## RESPONSES TO THE REVIEWER COMMENTS

### Reviewer #2

This manuscript by Chen et al. "Pairing FLUXNET sites to validate model representations of land use/land cover change" aims at evaluating the performance of CLM and Noah-MP LSMs in simulating the impacts of LULCC on surface energy balance. Authors rely on observations from paired FLUXNET sites for model validation. The manuscript contains new and significant research, especially efforts to utilize the FLUXNET observation in a paired scheme for LULCC analysis. Also, the choice of the LSMs are very well justified and results could potentially help inform future model improvement. Writing, especially methods and results, could be improved by adding sufficient details for an unfamiliar audience. In its current form the manuscript is very hard to follow, especially, if the reader is not familiar with all the LSM lingo. Also, excessive referring of key information by pointing the readers to tables does not help either.

**Figure R1.** Change in the diurnal (left) and seasonal (right) cycle of LE ( $\text{W/m}^2$ , a-b), H ( $\text{W/m}^2$ , c-d), Rnet ( $\text{W/m}^2$ , e-f), and G ( $\text{W/m}^2$ , g-h) from forest to open (open – forest) land excluding the pairs 3, 7, 12, and 15.

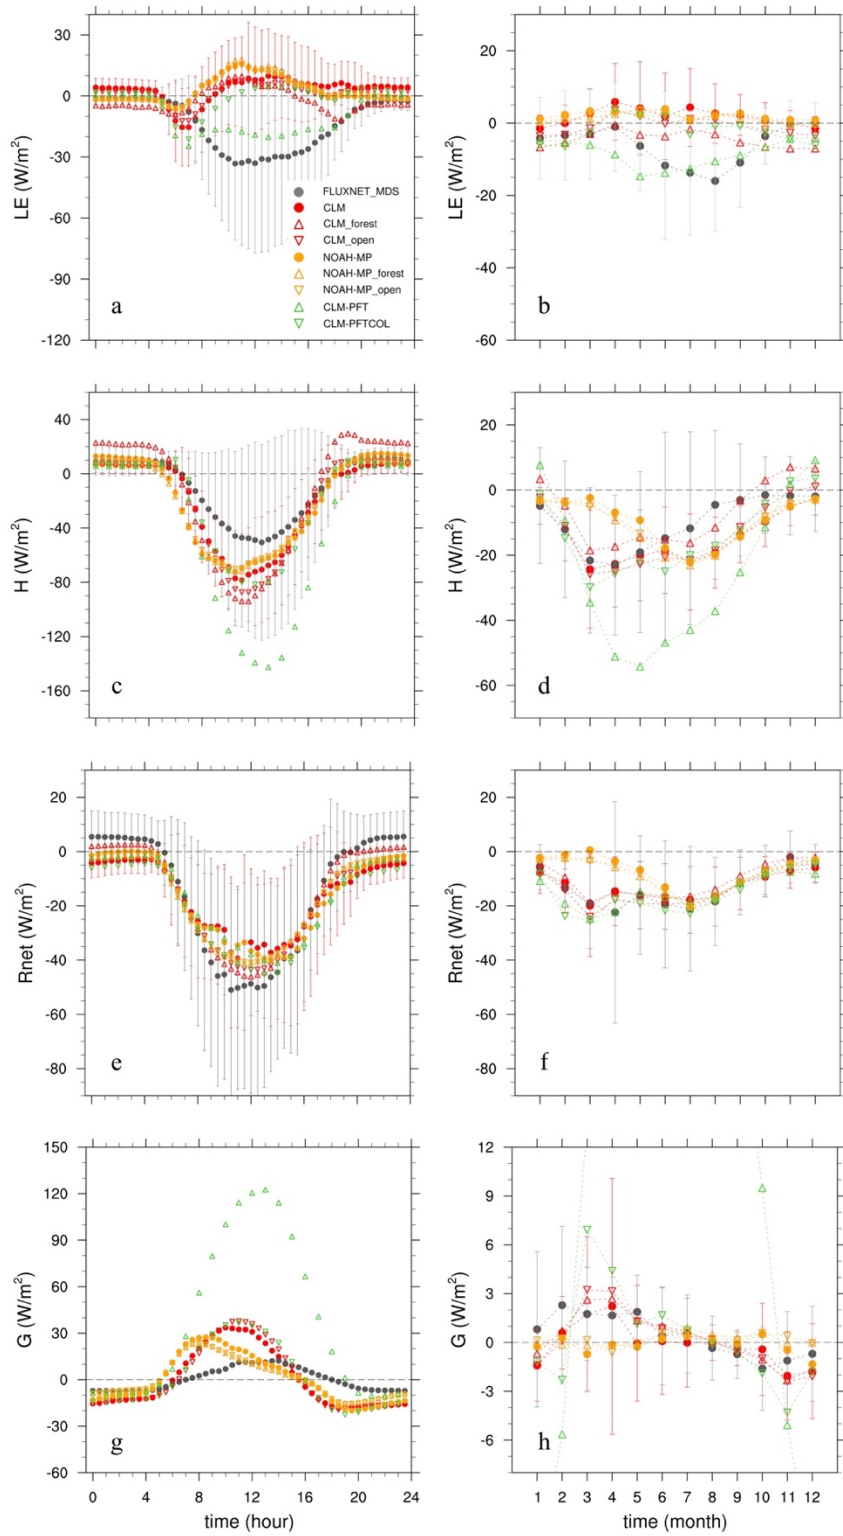
4) Considering the large difference in LE between some of the paired sites (in particular 3, 7, 12, and 15) I would suggest setting a threshold for inclusion. These differences in LE and H within paired sites are comparable to the corresponding changes under deforestation and cannot be overlooked.

That is a good point. Figure R1 (below) shows the changes in  $LE$ ,  $H$ ,  $G$ , and  $R_{net}$  from forest to open (open – forest) land excluding the pairs 3, 7, 12, and 15. The exclusion of these pairs shows very consistent patterns with the results including all sites (Figure 2-9), even though there is a slight influence on the magnitude of changes in fluxes (e.g., daytime  $LE$ ). Therefore, large changes in surface fluxes within some pairs (or “outliers”) do not affect the robustness of our results. We have included this figure in the supplementary information (Figure S1), and added some discussion in the revised manuscript (P10, L204-206).
